Nebraska Public Power District

Subject: Supplemental Reload Licensing Submittal and Proposed
Technical Specifications for Cooper Nuclear Station
Reload 4, Cycle 5, NRC Docket No. 50-298, DPR-46

Proposed Changes to
Cooper Nuclear Station
Technical Specification Pages

Figure 3.11-1.3. Maximum Average Planar Linear Heat Generation Rate versus Exposure with LPCI Modification and Bypass Flow Holes Plugged, 8D250 Fuel

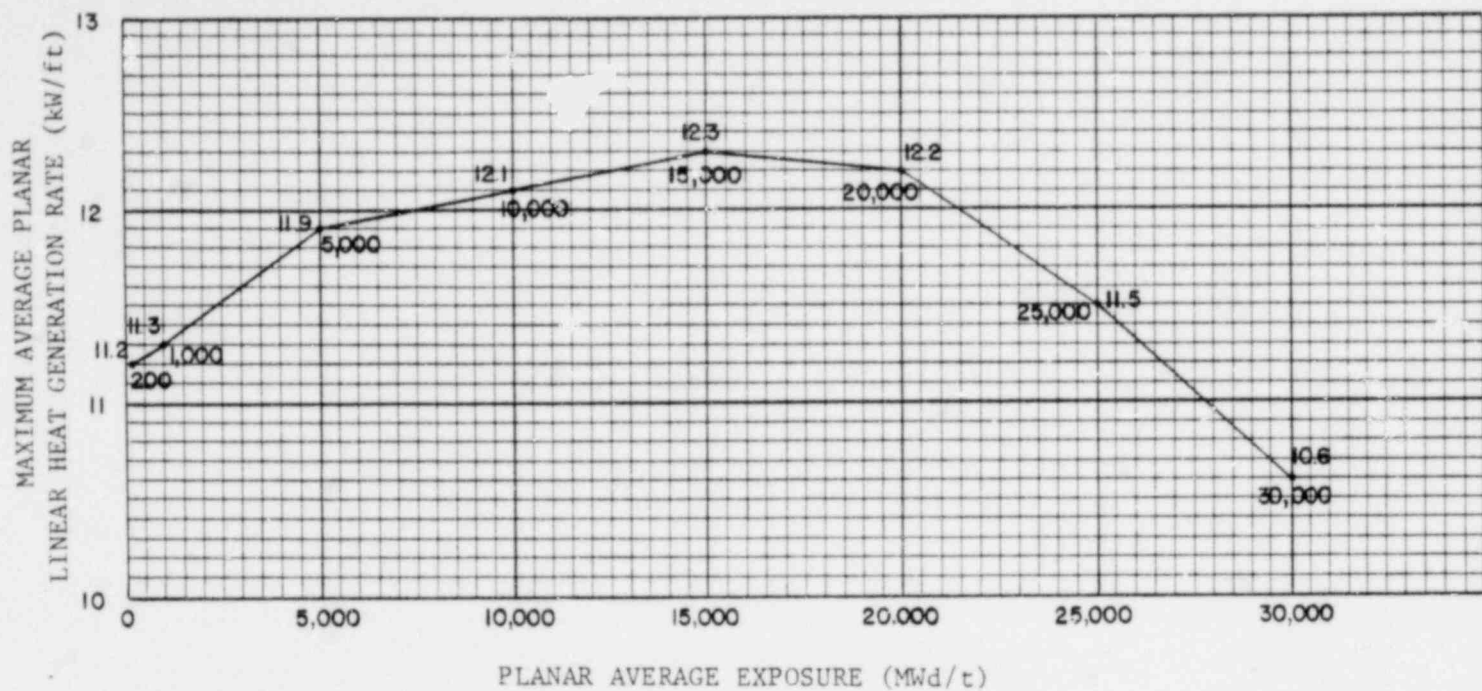
1. The Rod Block Monitor setpoint is being changed for 106% to 105% due to the results of the rod withdrawal error analysis.
2. The operating Minimum Critical Power Ratio (MCPR) limits and Overpressurization Analysis results are revised.
3. The densification power spiking penalty factor is being deleted for 8x8 fuel.
4. The low pressure main steam line isolation signal is being reduced from 850 psig to 825 psig. Justification for this change is enclosed as Attachment 2.
5. Various reference and editorial changes.

During steady state power operation, the APLHGR for each type of fuel as a function of average planar exposure shall not exceed the limiting value shown in Figure 3.11-1. If at any time during steady state operation it is determined by normal surveillance that the limiting value for APLHGR is being exceeded action shall be initiated within 15 minutes to restore operation to within the prescribed limits. If the APLHGR is not returned to within the prescribed limits within two (2) hours, the reactor shall be brought to the Cold Shutdown condition within 36 hours. Surveillance and corresponding action shall continue until the prescribed limits are again being met.
